SCALE: As-Noted  
 DATE: 1/17/00  
 PROJECT: Stockton CA, Parking Garage  
 Arch. Details, Parking Struct.

GENERAL CONTRACTOR  
 Turner Constr.  
 DRAWN BY: JM  
 CHECKED BY:  
 JOB NO. 1282  
 DRAWING NUMBER AD-9

CUSTOMER: TURNER CONST  
 PROJECT: ESSENTIAL SERVICES BLDG  
 LOCATION: STOCKTON, CA

ANCHOR BOLT LAYOUT GARAGE STAIRS

Date	5-11-2000
Scale	1/8" = 1'-0"
Drawn	IS
Job	451
Sheet	PT-17
Of	Sheets

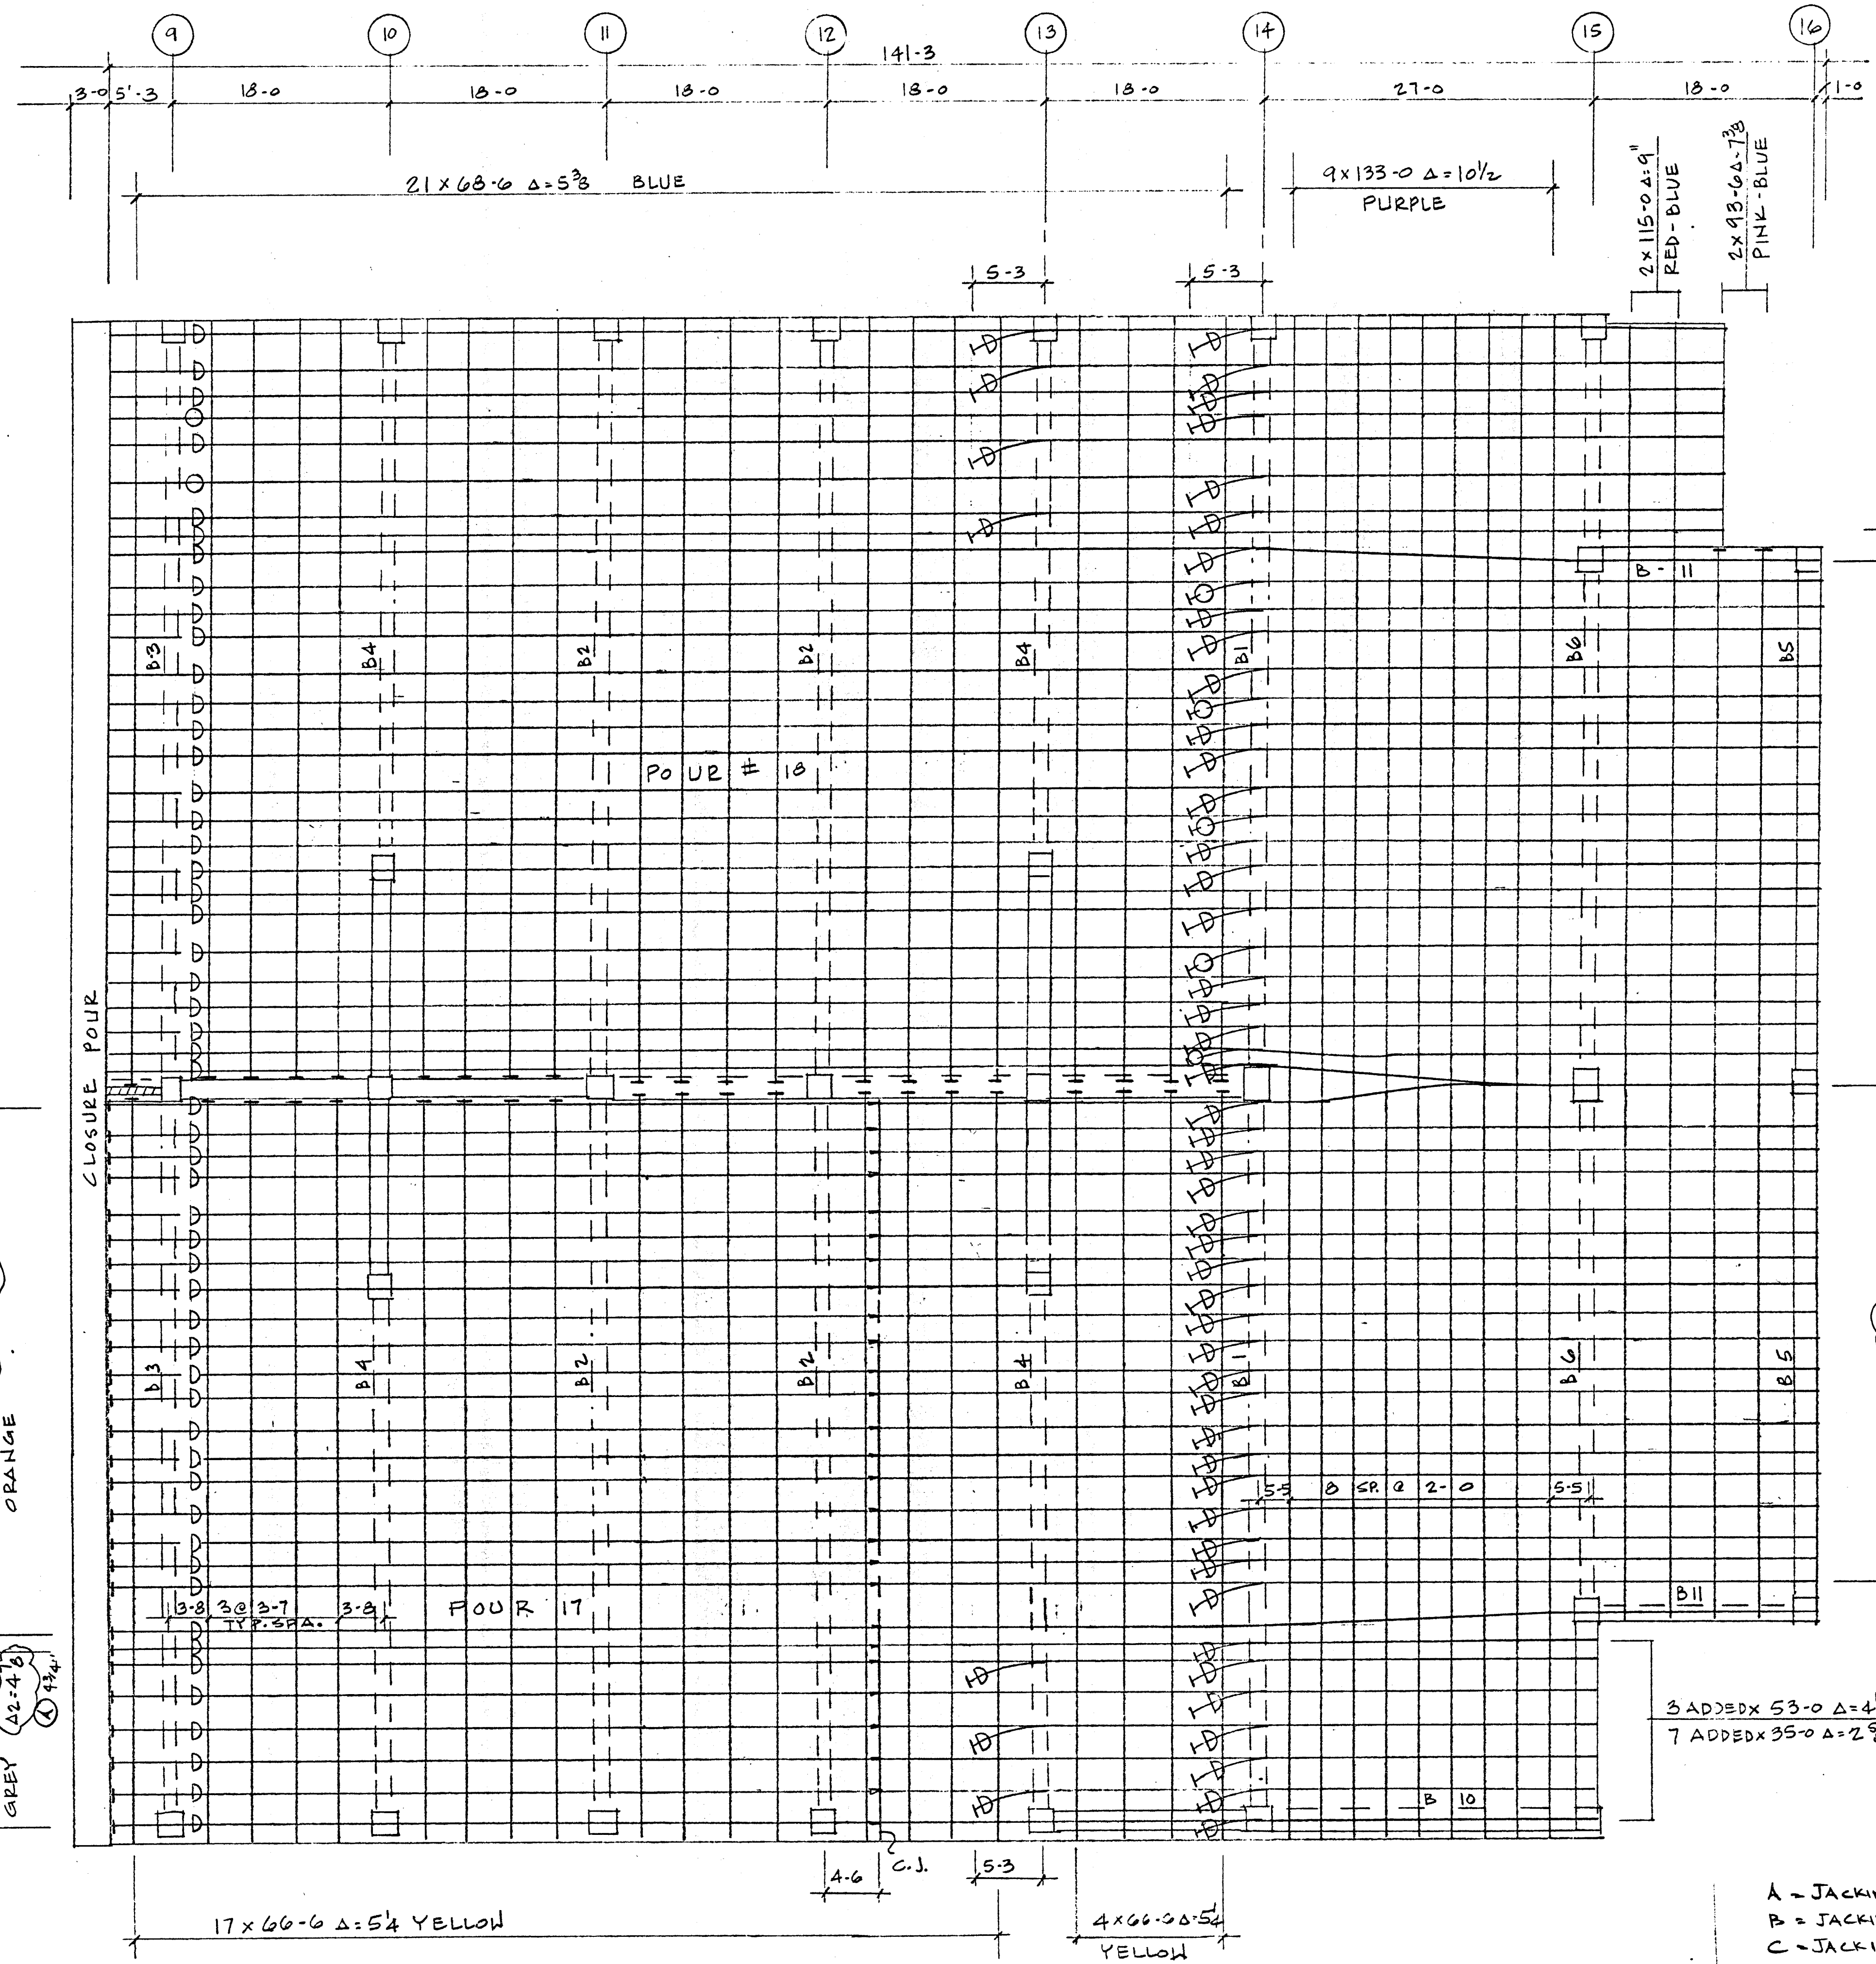
delete one cable this bay 13'6"

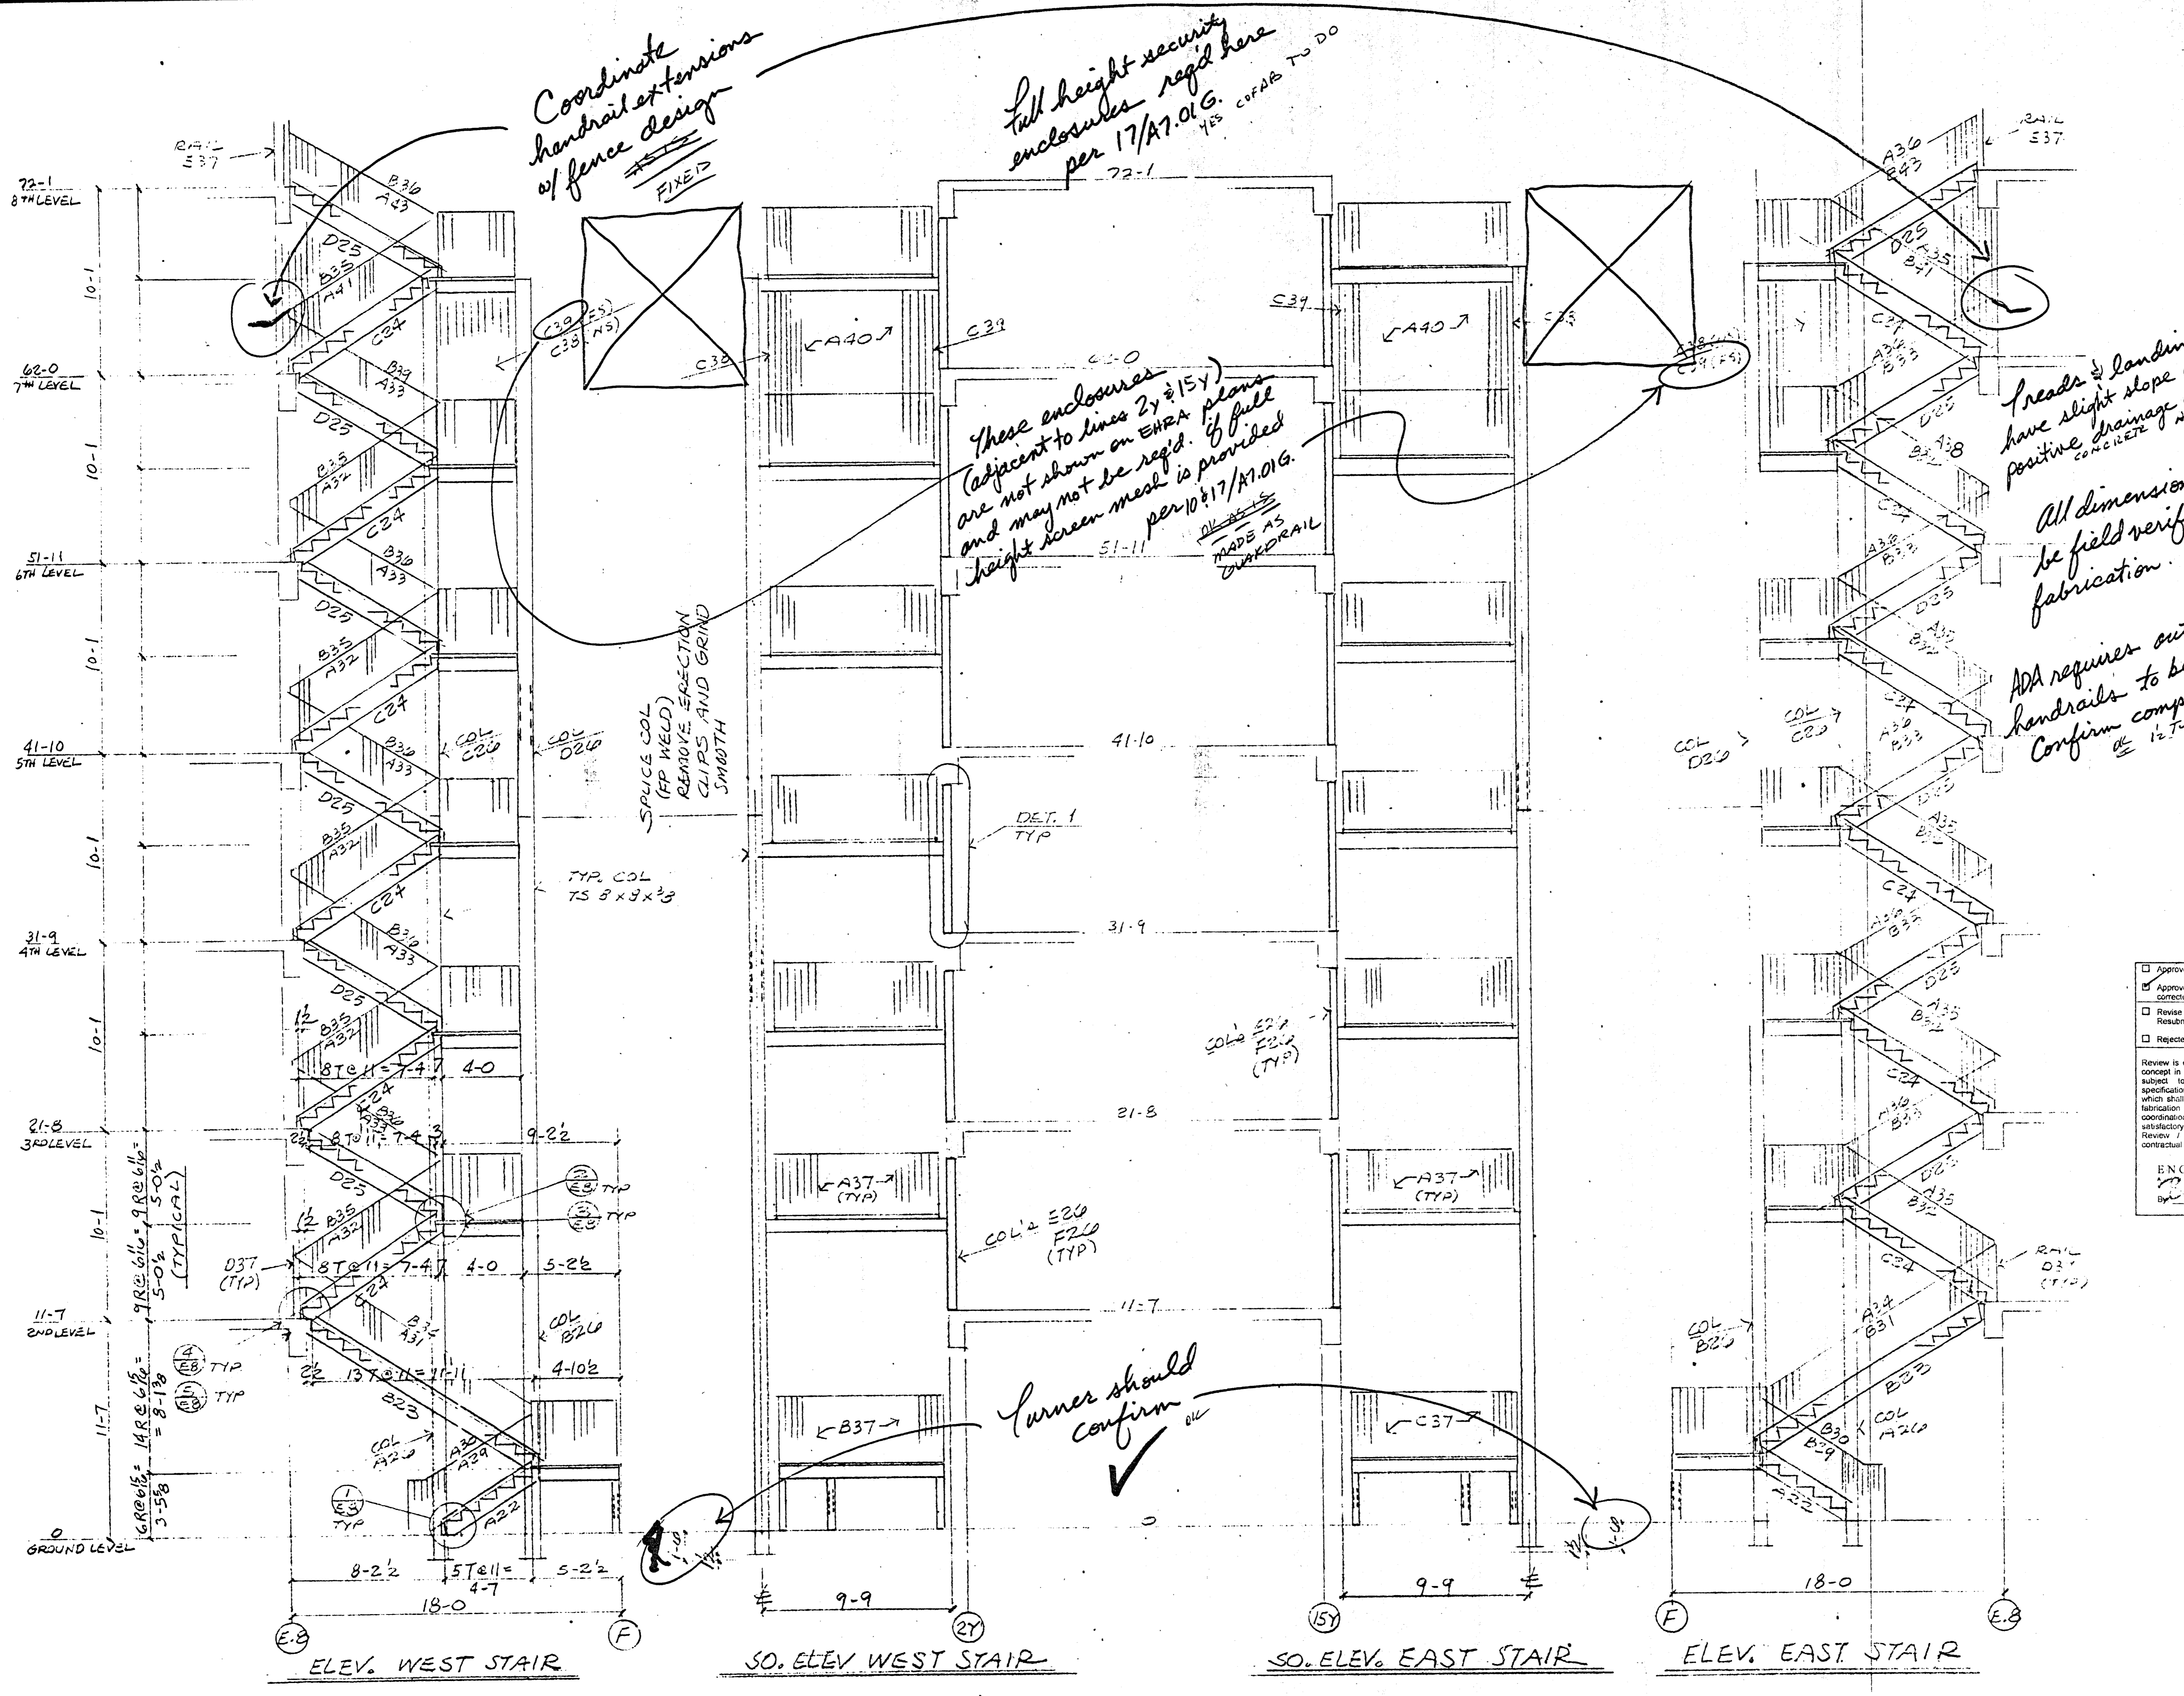
See sheet EB for commands  
 Architect verify stair dimensions & handrail type

**REVISE & RESUBMIT**  
**STAIRS ARE REQUIRED TO BE STEEL STAIRS**

Submit plans & calcs. to Bldg. Dept. for approval. ✓ - TURNER

<b>COFAB STEEL CORP.</b> VALLEJO, CA			
CUSTOMER	TURNER CONST	REV	
PROJECT	PARKING GARAGE	DATE	
LOCATION	STUCKTON, CA	APPROVAL	
LAYOUT GARAGE STAIRS		OFFICE	
		SHOP	
		FIELD	
		CUSTOMER	
DRAWN BY	ML	DATE	3-16-00
CHECKED BY		DATE	
APPROVED BY		DATE	
JOB NO.		DRAWING	REV
		965	E7

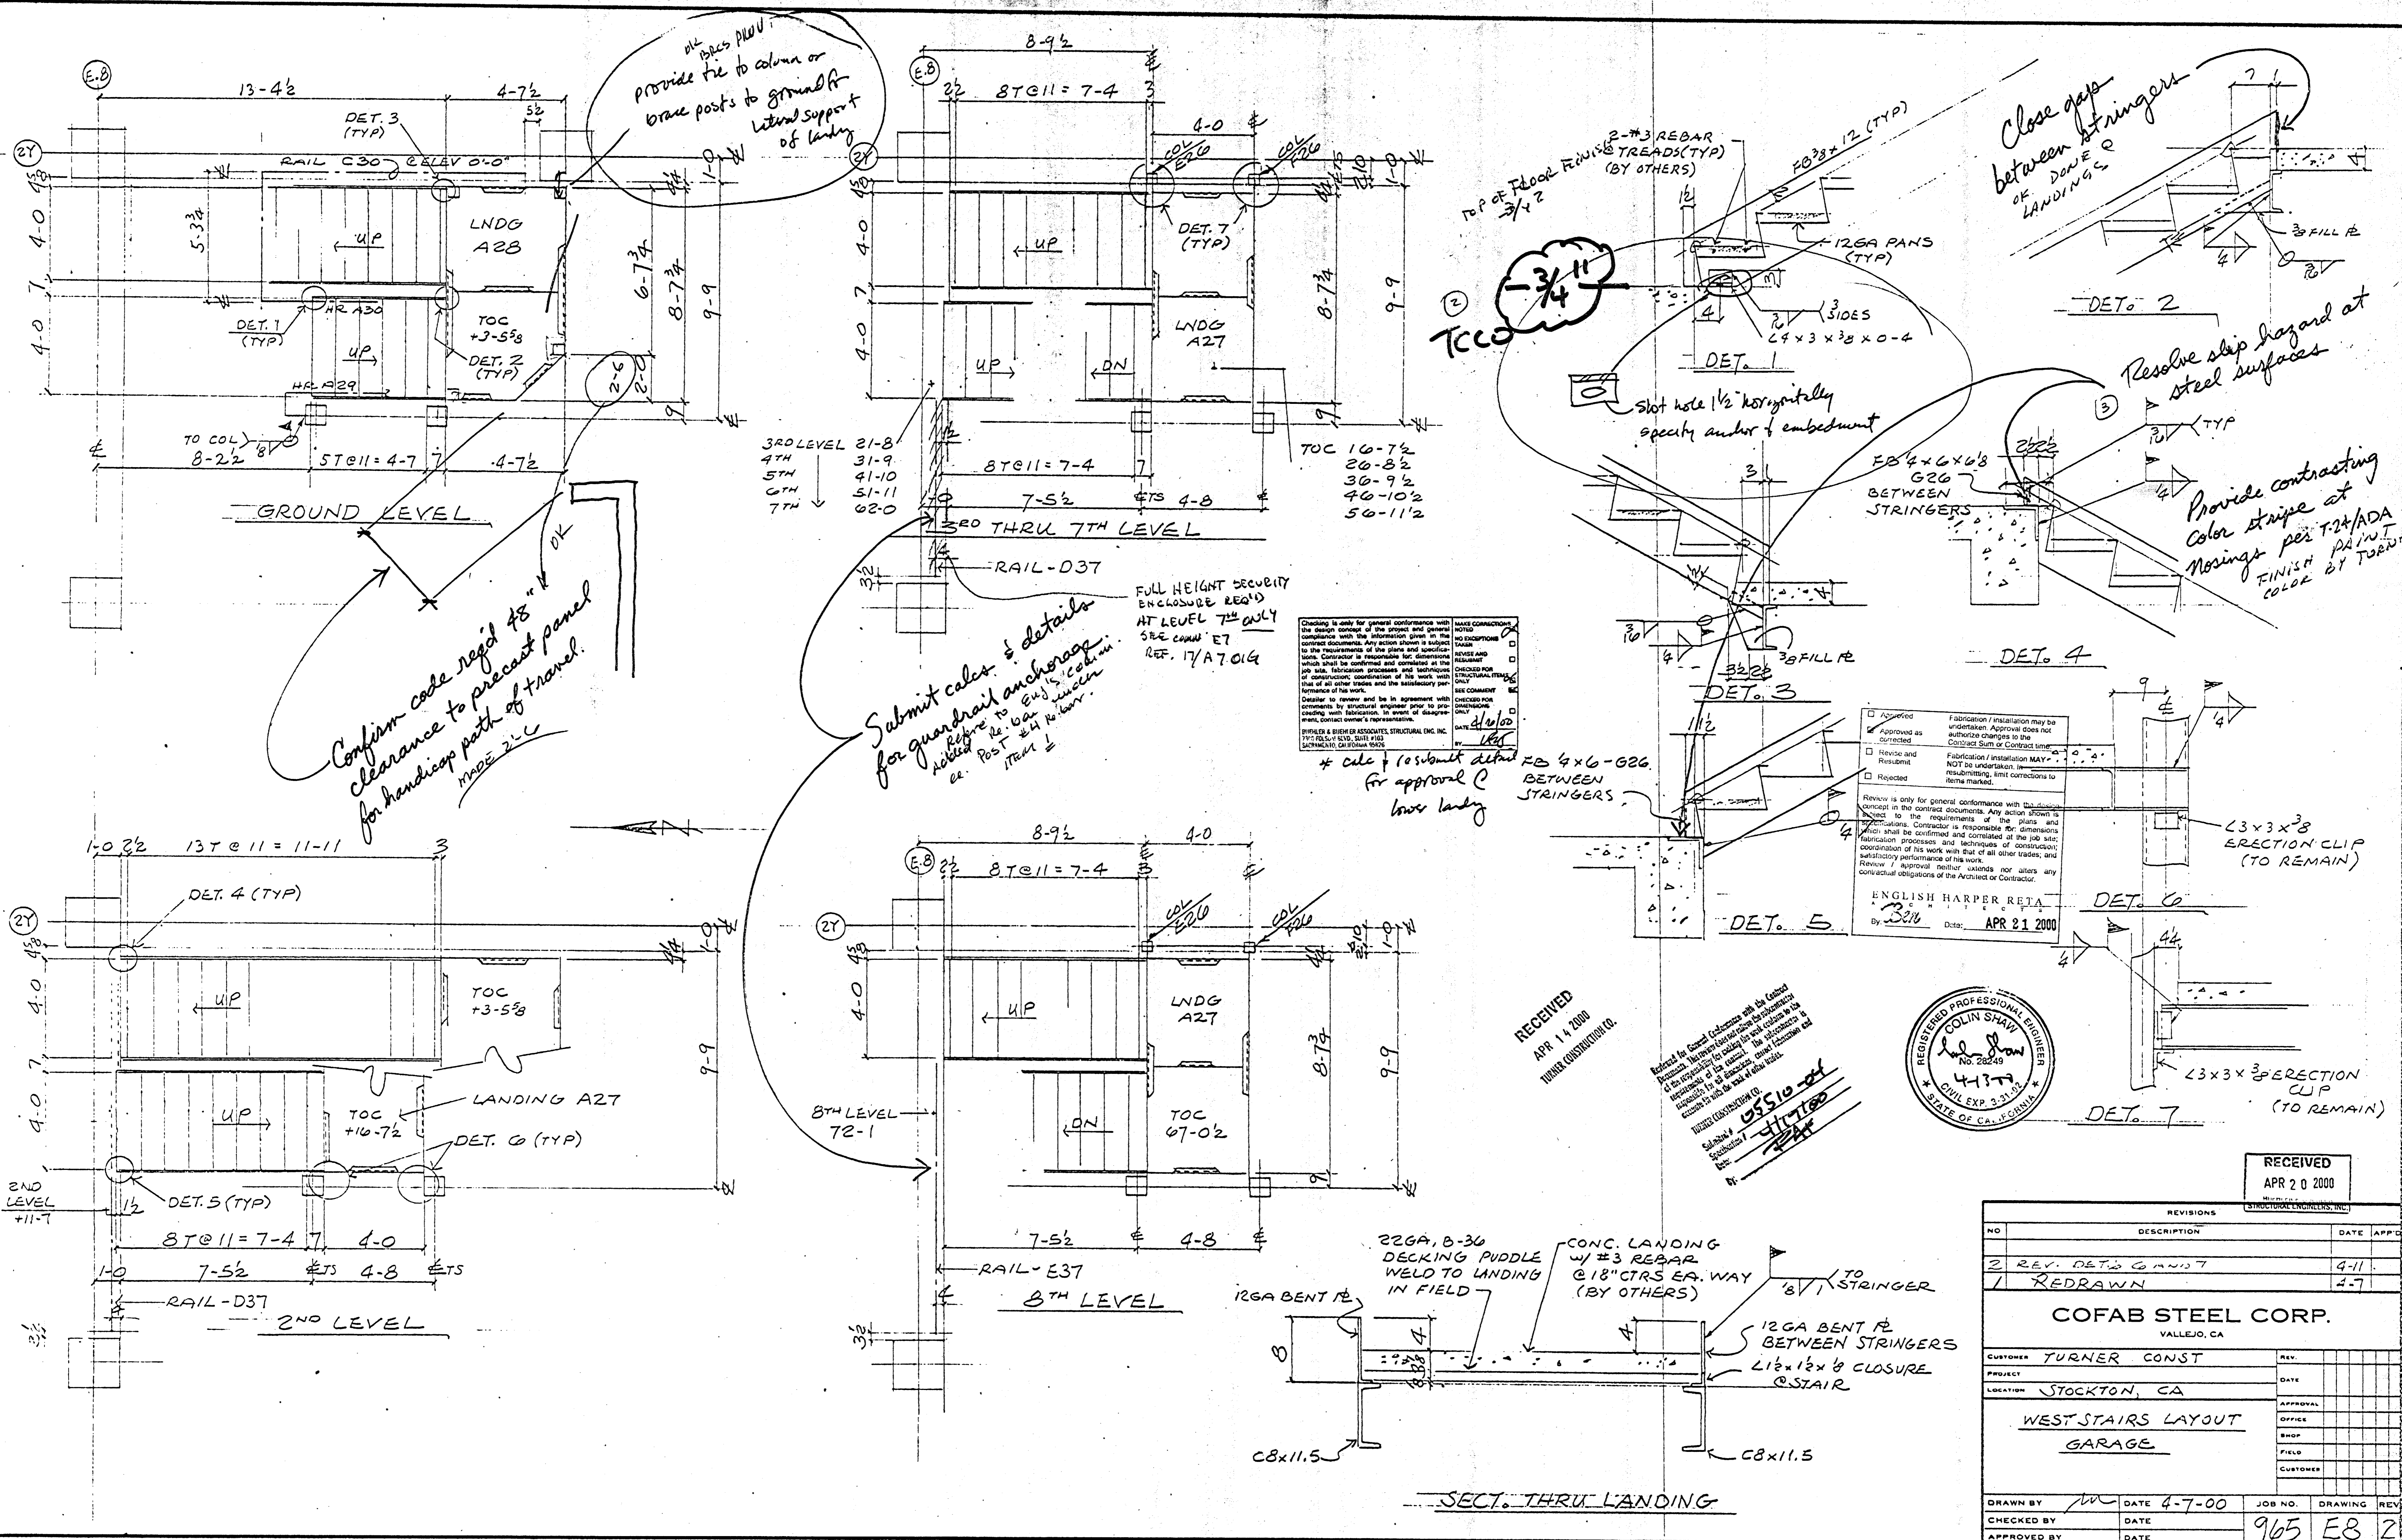
These enclosures (adjacent to lines 2y & 15y) are not shown on EHPA plans and may not be req'd. If full height screen mesh is provided per 10 & 17/A7.01.G.  
 MADE AS HANDRAIL
